1022 NE 68TH ST TOWNHOMES

ADMINISTRATIVE DESIGN REVIEW - 11/8/2021
1022 NE 68TH ST.
SEATTLE, WA 98115

3037024-EG
3036465-LU associated LBA

STREET VIEW ALONG NE 69TH ST

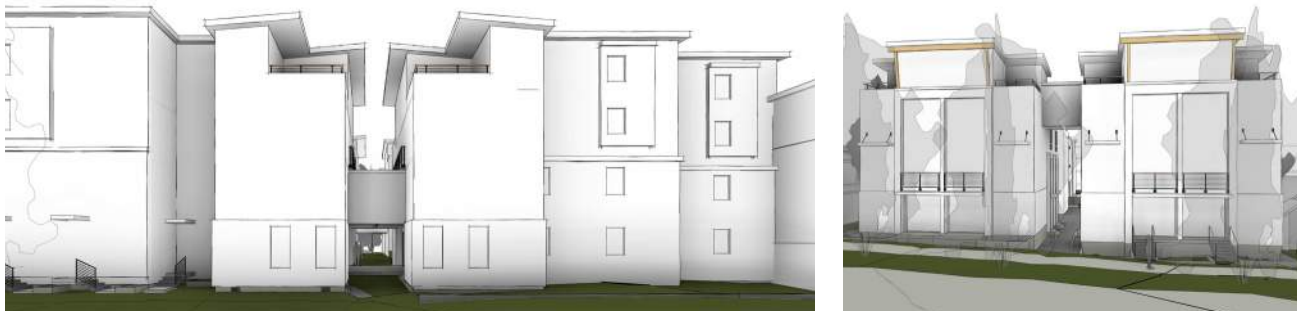
1f. Staff supports the overhead massing bridge between units 9/10 and 11/12 as it provides a scaling element and overhead weather protection with four well-organized private entries below. (PL3-A-3, PL3-A-4, DC2-C-2)

Response 1e:
The 'bridge' between Units 18 and 19 have been removed, providing a clear view from North to South through the entire site.

Response 1f:
The overhead massing bridge between Units 9/10 and 11/12 has been retained.

FACADES AT ADJACENT PARCELS

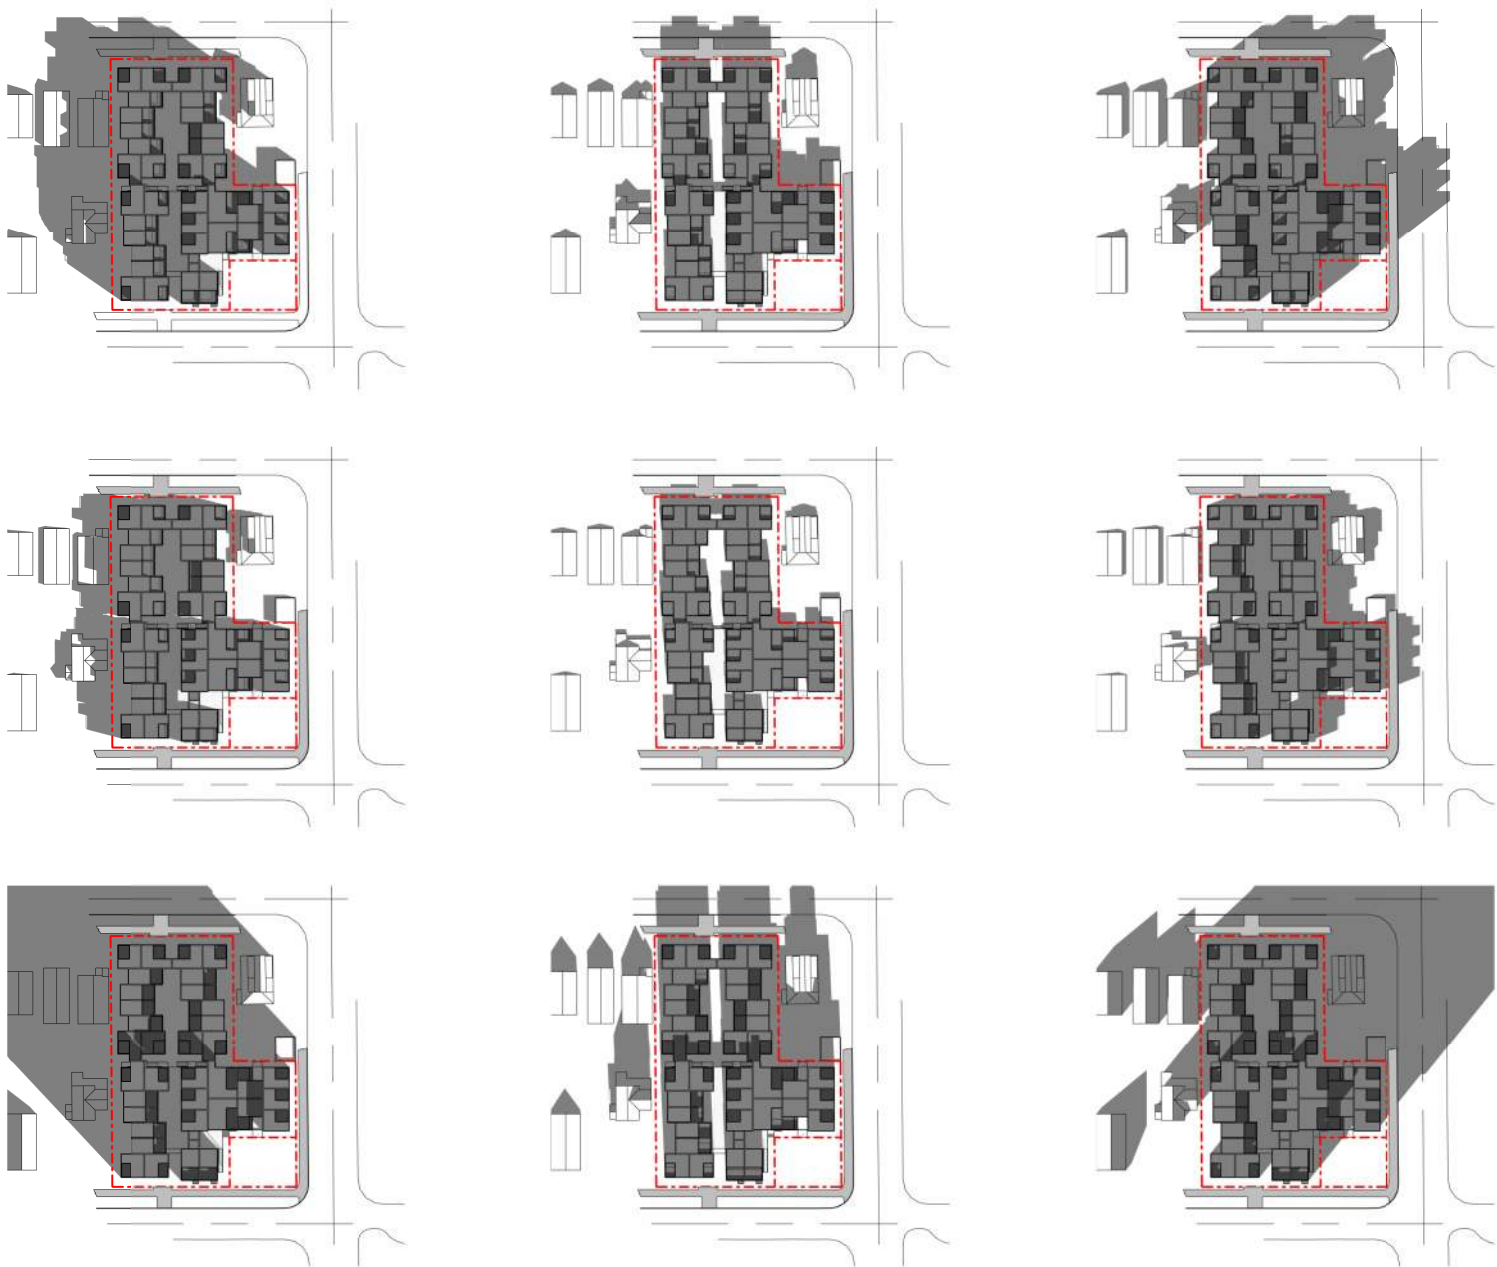
1h. In response to public comment, staff specifically prioritizes Design Guideline CS1-B-2, Daylight and Shading; Maximize daylight ... and minimize shading on adjacent sites through the placement and/or design of structures on site. (CS1-B-2, CS1-I-i)

Response 1h:
Solar access and protection from undue shading have been preserved for this site and the neighbors by way of proposing separated buildings with relief in massing at the fourth story. The project does not utilize the fifth story of height limit that is available. Further, the project is well under the allowable FAR limits. An alternative proposal for this site would be a large apartment building, singular in massing. This alternate would allow full utilization of the available FAR and height limit and would provide a significantly greater impact to neighboring properties in terms of solar access and shading.

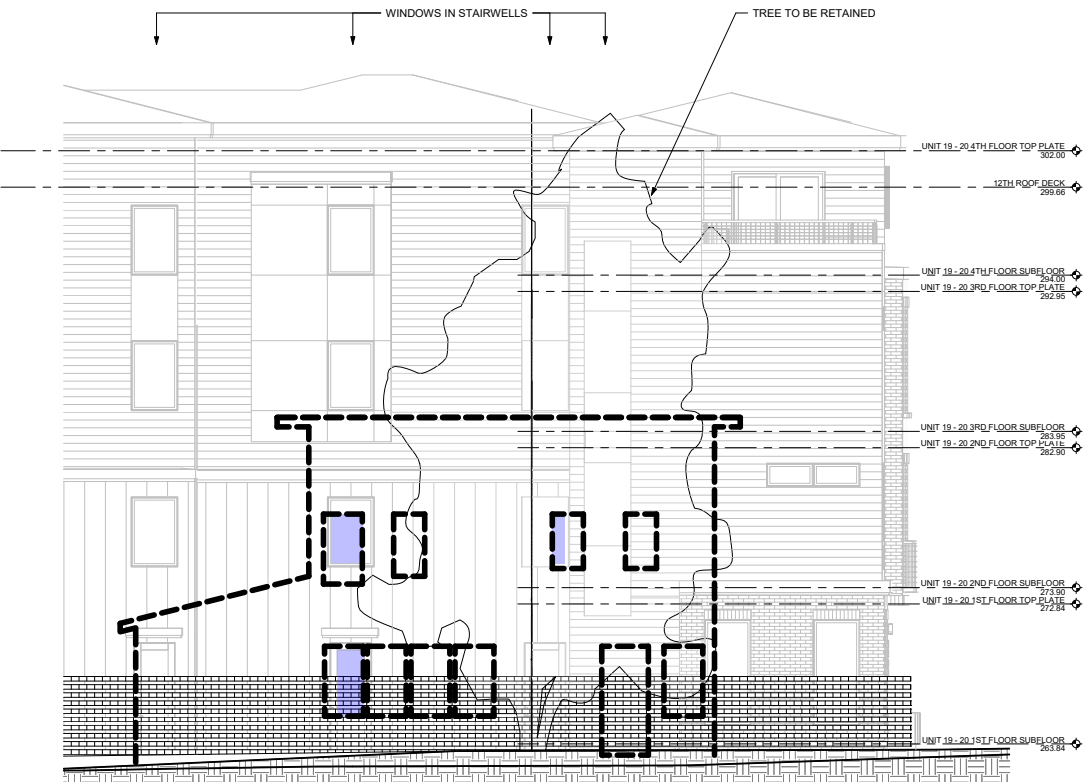
2e. In response to public comment, staff specifically prioritizes Design Guideline CS2-D-5, Respect for Adjacent Sites, and DC1-C-4, Service Uses. Incorporate design features to mitigate privacy impacts. Provide a window overlap privacy study in the Recommendation packet. (CS2-D-5)

Response 2e:
The project has generally been designed for non-street-facing units to look towards the interior of the site. The primary windows look down into the courtyard, while only secondary windows face out towards the neighbors. The units are typically designed with stairways adjacent to neighboring property lines, where windows are less frequent and the internal spaces are occupied less frequently. Wood fences are used along all side property lines to preserve privacy between the project and adjacent lots. A window privacy study is included within this packet.

COURTYARD OVER GARAGE PLAN

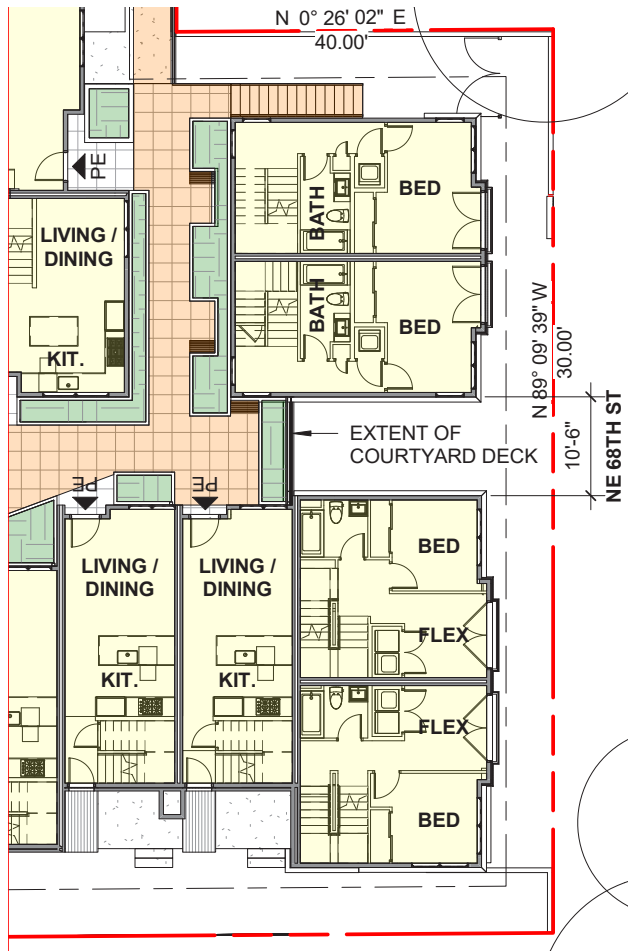
3c. To minimize impacts of vehicular access on building aesthetics and create additional usable open space, extend the deck of the overhead central courtyard over the driveway to the extent possible. (DC1-C-2, DC3-B, DC3-C-2)

Response 3c:
The deck has been aligned to cover the extents of the garage. It is not extended further as doing so would create overhead clearance conflicts for vehicles in the driveway. An extension would also create structural problems and so could not be extended far enough to provide meaningful landscape or courtyard spaces. The space on the courtyard deck is utilized as a semi-private niche for residents to enjoy.

CIRCULATION PLAN AND DETAILS OF PEDESTRIAN ACCESS FROM THE GARAGE TO THE COURTYARDS

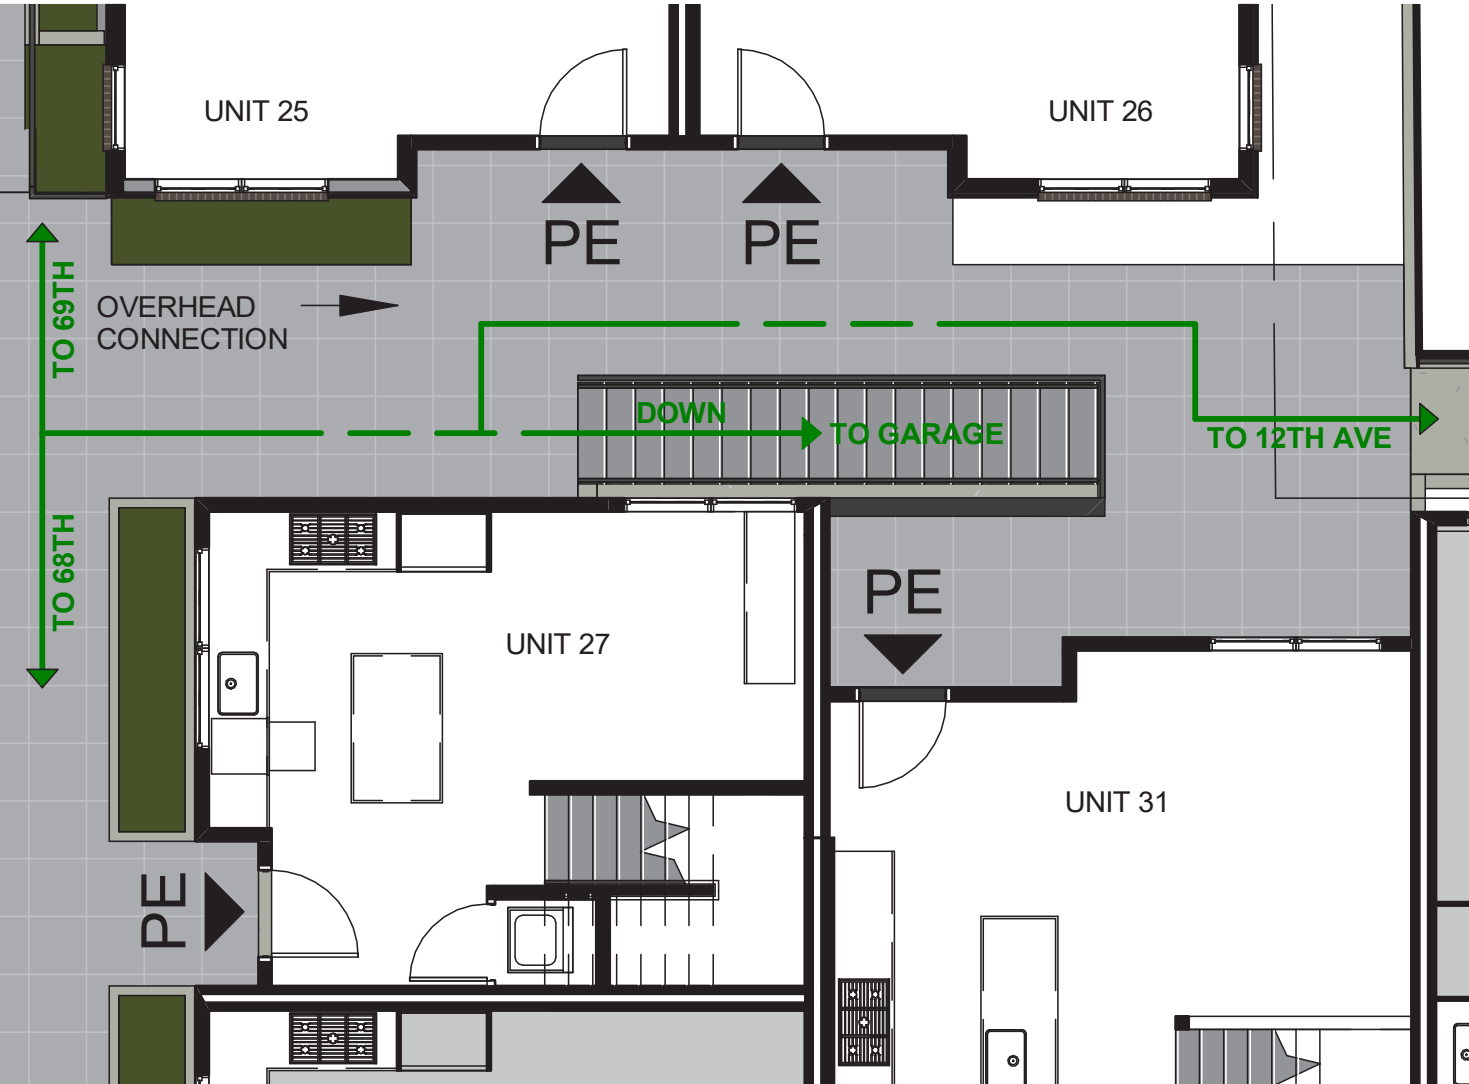
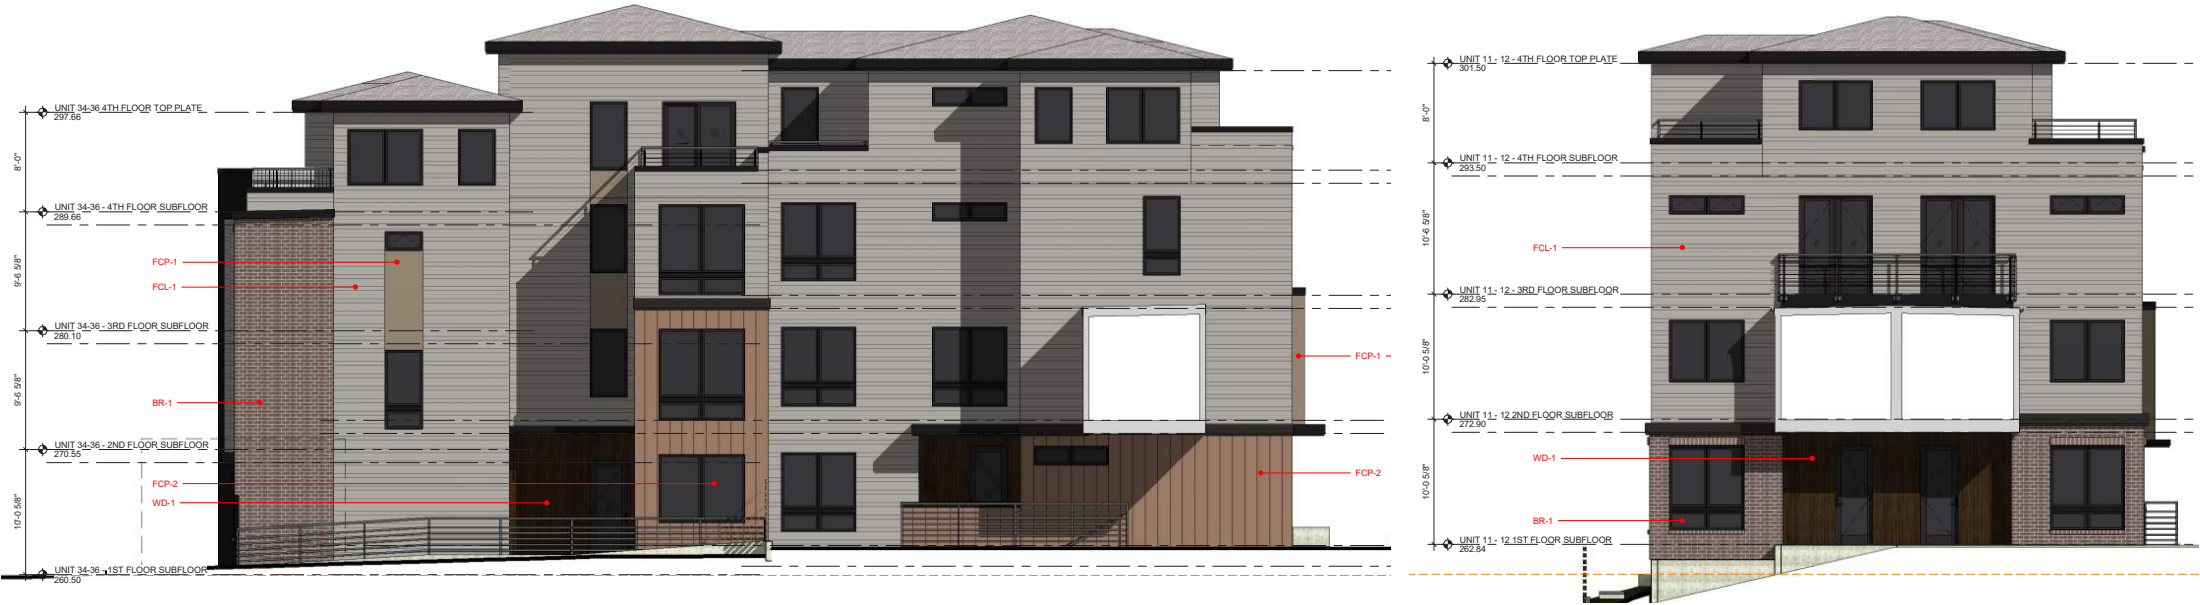
4b. Staff is concerned about the jumble of overlapping uses between units 25/26 and 27/31, including the Stair landing, three private entries and a common path. To simplify the configuration, group common uses and promote ease of access, reorient the stair by 180-degrees and integrate the landing into the design of the central courtyard. Cover the open stair with the courtyard deck to the extent possible. Distinguish the common access path from the three individual entries; the path should not traverse the entry landings. (PL1-B, DC3)

Response 4b:
The stairs have been rotated, and the walkway has been pulled over a portion of the stairs. A solid wall has been added at the entry to Unit 28 for enhanced privacy.

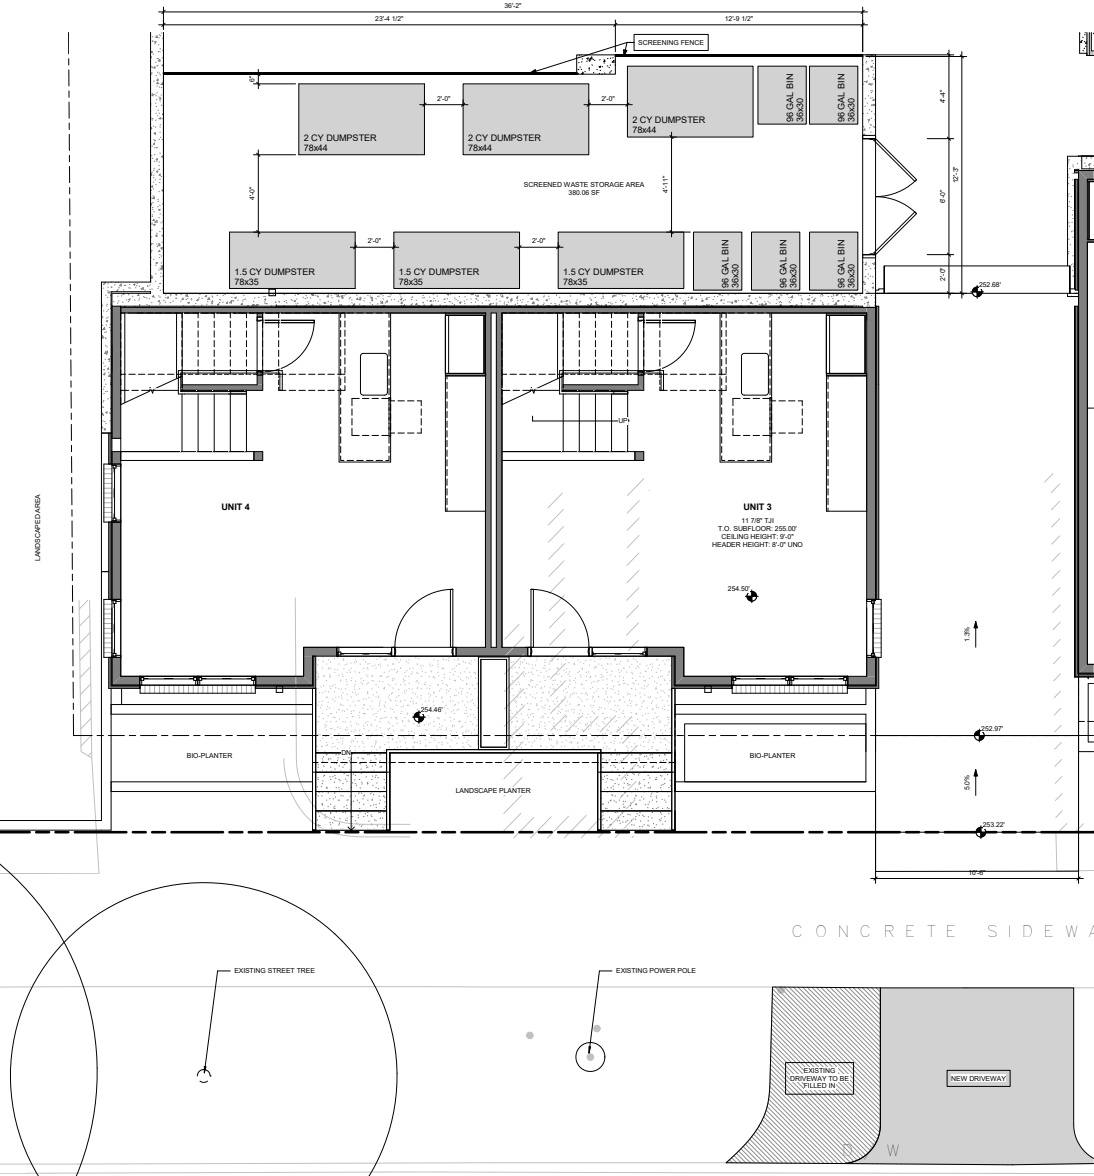
- 5b. Staff strongly supports the intent to internalize common waste storage within the parking garage, but notes there are two smaller at-grade waste storage areas in the northwest and northeast corners of the site. In response to public comment, internalize all waste storage. If unable to do so, waste storage should be located and attractively screened to minimize impacts on residents of adjacent sites, as well as future residents of the proposed development. (CS2-D-5, DC1-C-4)

- 5c. In agreement with SDOT, staff recommends working with Seattle Public Utilities on solid waste storage, staging and access to reduce impacts on the public realm.(DC1-C-4)

Response 5b:
All storage for waste has been relocated in a single location within the garage. It will be screened from view, yet accessible to the waste collection crew.

Response 5c:
The project team is in ongoing coordination efforts with Seattle Public Utilities.
